HEATHER ADDITION

Re: S/D 98-37 -- Final Plat of HEATHER ADDITION

Re: S/D 98-37 -- Final Plat of HEATHER ADDITION

CASE NUMBER: S/D 98-37 - HEATHER ADDITION

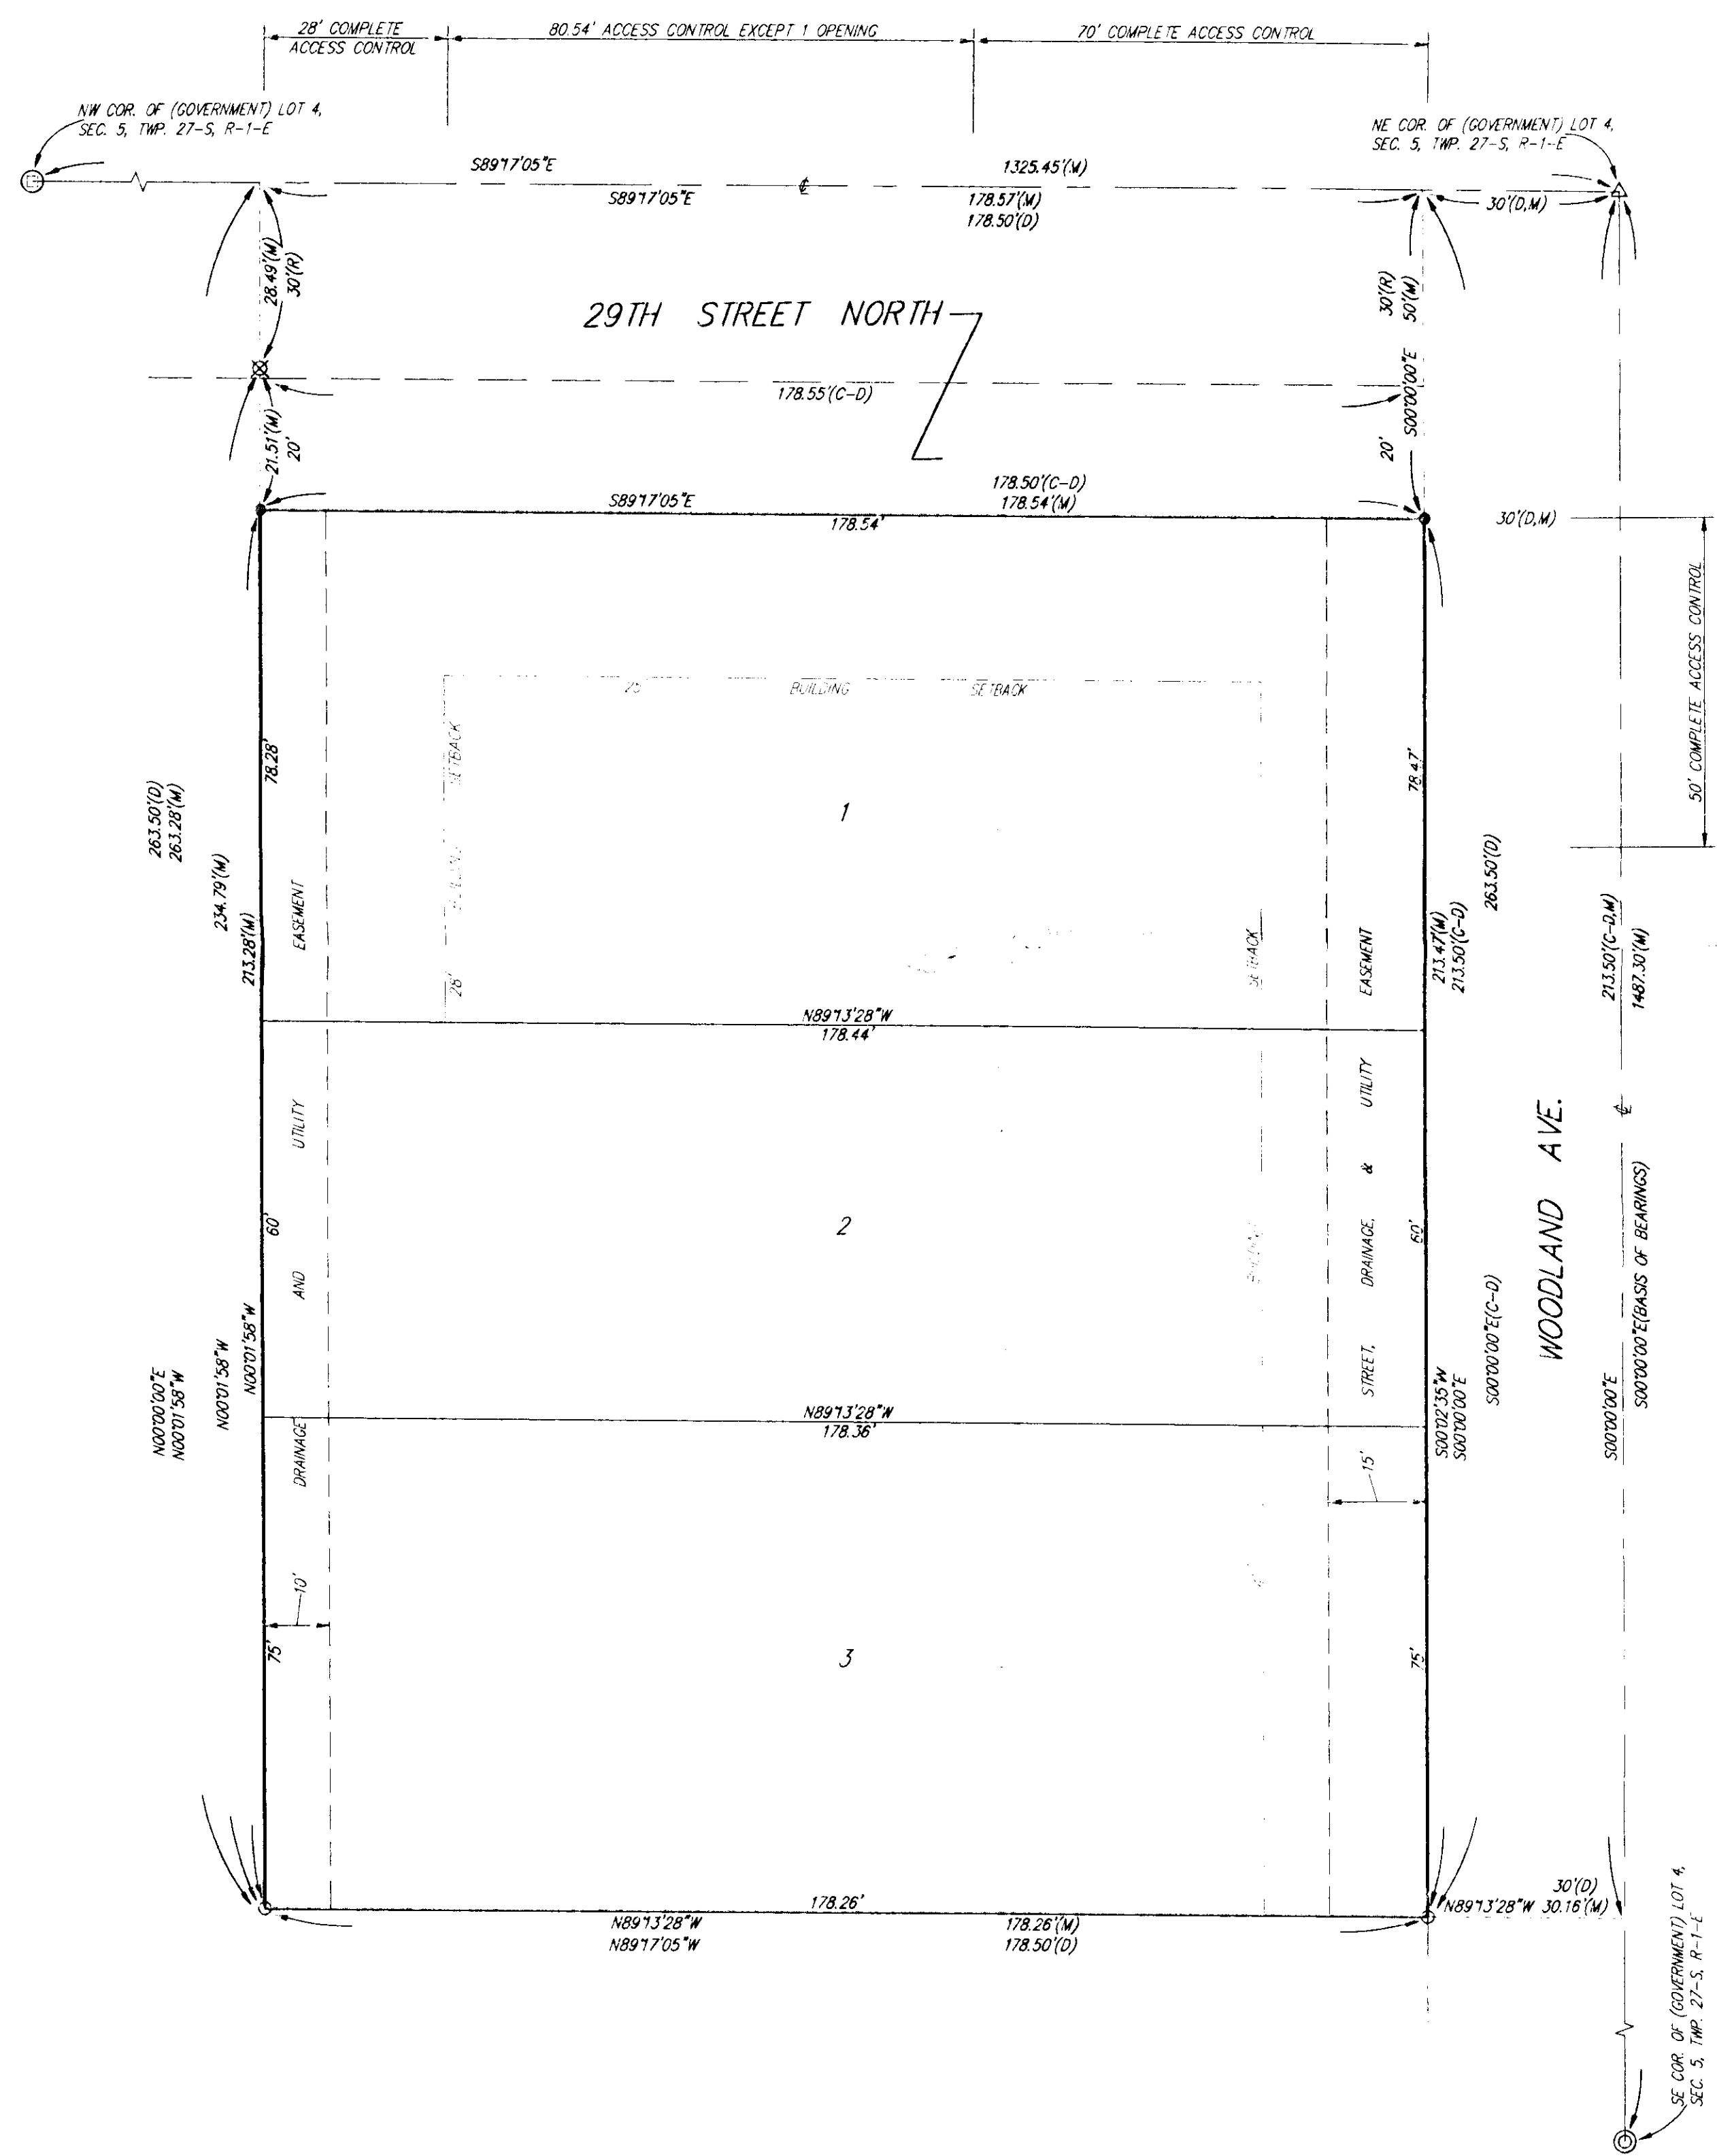
- A. Existing municipal services appear to be available to this site. City Engineering needs to verify if any other guarantees are required. No additional guarantees are needed. Woodland Street contains substandard pavement and an affidavit not to protest future paving to City standards will be required of the applicant.
- B. If improvements are guaranteed by petition, a notarized certificate listing the petitions shall be submitted to the Planning department for recording.
- C. City Engineering needs to comment on the status of the applicant's drainage concept. The drainage plan is approved. A cross-lot drainage agreement is needed or a drainage easement needed to be denoted on the plat along the western line (coinciding with the utility easement).

- D. Traffic Engineering needs to comment on the need for access controls along perimeter streets, and additional right-of-way. Traffic Engineering requests an additional 20-foot of right-of-way along 29th Street North. Complete access control along 29th Street North is required along the westernmost portion of the northern lot and the east 70 feet. Along Woodland, 50 feet of complete access control will be required from the intersection.

- G. The applicant needs to revise the legal description to accurately portray the land being platted. The distances on the drawing are not identical to those in the legal description.

- I. A restrictive covenant shall be submitted limiting the uses of lots 2 to those permitted under the SF-6, Single-Family Residential District.
- J. The final plat tracing shall reference a tie point to a section corner.

- C. City Engineering needs to comment on the status of the applicant's drainage concept. The drainage plan is approved. A cross-lot drainage agreement is needed or a drainage easement needed to be denoted on the plat along the western line (coinciding with the utility easement).

- A drainage easement has been denoted on the plat as requested.
- D. Traffic Engineering needs to comment on the need for access controls along perimeter streets, and additional right-of-way. Traffic Engineering requests an additional 20-foot of right-of-way along 29th Street North. Complete access control along 29th Street North is required along the westernmost portion of the northern lot and the east 70 feet. Along Woodland, 50 feet of complete access control will be required from the intersection.

G. The applicant needs to revise the legal description to accurately portray the land being platted. The distances on the drawing are not identical to those in the legal description.

J. The final plat tracing shall reference a tie point to a section corner.

A drainage easement has been denoted on the plat as requested.

The additional right-of-way and access controls have been included on the final plat.

- The additional right-of-way and access controls have been included on the final plat.
- E. Traffic Engineering needs to comment on the need for any street improvements.
